GROUP 5 REAR AXLE ASSEMBLY

5-1 REAR AXLE CHANGES

The rear axle assembly is essentially the same design as the 1952 rear axle assembly; however, a number of changes were made which affect interchangeability of parts and some service procedures. This section will describe the changes and their related service procedures. For all other information refer to Group 5 in the 1952 Buick Shop Manual.

Figure 5-1—Propeller Shaft Seal

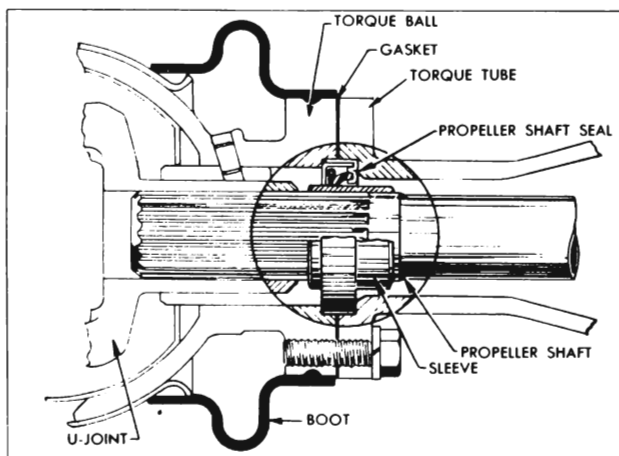
The seal is installed with the spring loaded lip edge toward front of car, and this edge bears against a sleeve which is pressed on the propeller shaft in position to close off the splines against passage of oil. A paper gasket is used between the torque tube and torque ball.

A new propeller shaft seal was used at start of 1953 production. The new seal is tightly fitted into a recess in the torque tube front flange. Approximately half of the seal retainer projects into a recess in the torque ball to act as a pilot. The universal joint seal formerly located at this point in torque ball has been eliminated. See figure 5-1.

Figure 5-2—First and Second Type Differential Carriers

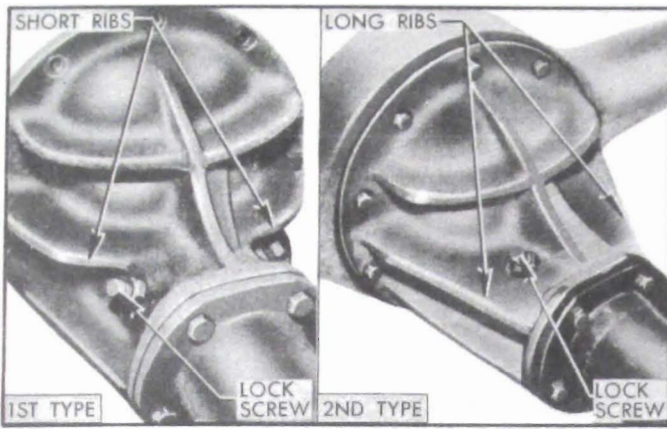
After 1953 production started, a new differential, propeller shaft, and third member housing assembly was introduced on all models. The change permits use of larger pinions to provide faster rear axle gear ratios. While the second design is essentially the same as the first, none of the parts are interchangeable because of differences in dimensions. At the same time this change was made, the speedometer driving worm gear was changed to 8 teeth (par. 4-1, e).

First and second differential designs may be identified by the external appearance of the carriers. In the second type, the upper side ribs are extended forward to the front flange and the pinion bearing sleeve lock screws are rotated so that the bottom screw is no longer straight down. See figure 5-2.

Figure 5-5—Pinion Setting Tables for Second Type Carrier

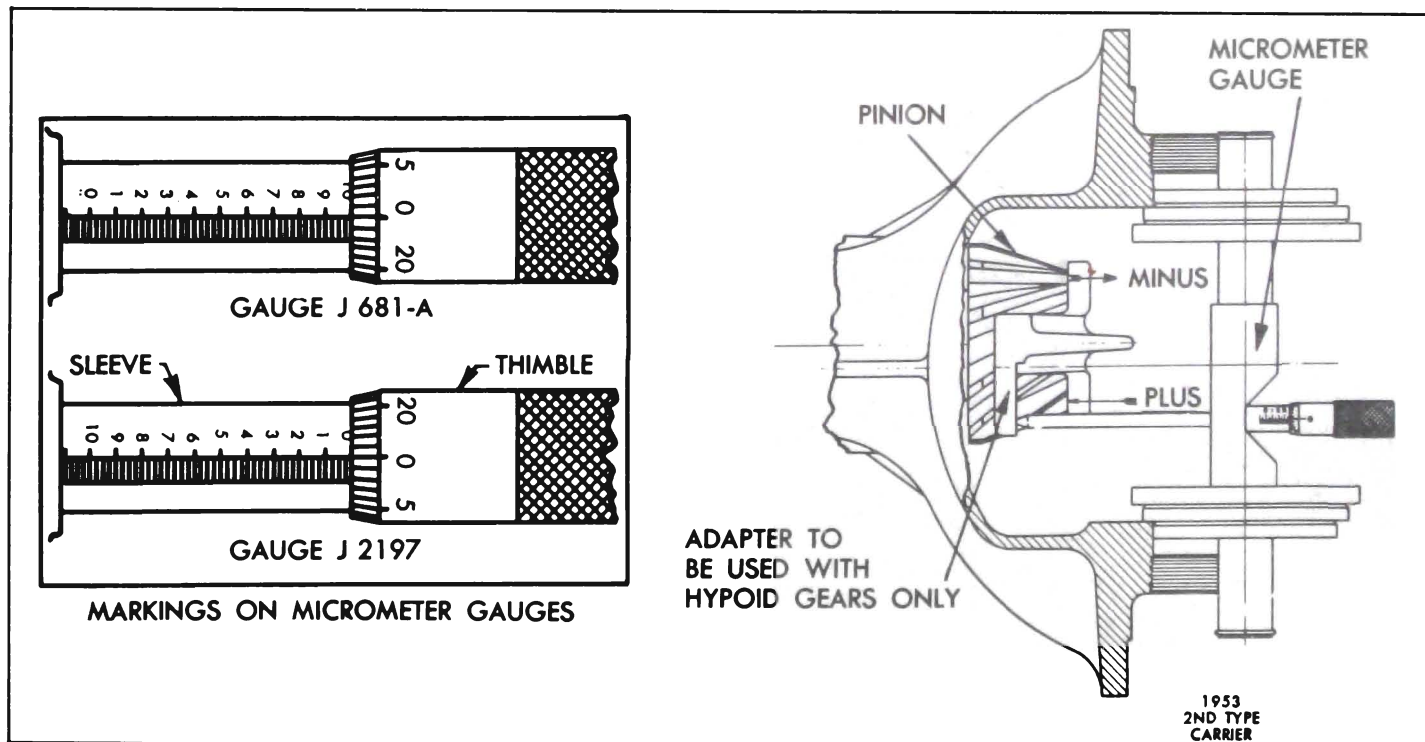
(2) *Second Type Carrier.* When checking pinion setting in the second type carrier use the new Adapter J 2197-9 with Clamp J 2197-8 and also use the new pinion setting table given in

figure 5-5 of this manual. The new table is based on a nominal setting of .317 for Gauge J 681-A and .864 for Gauge J 2197.
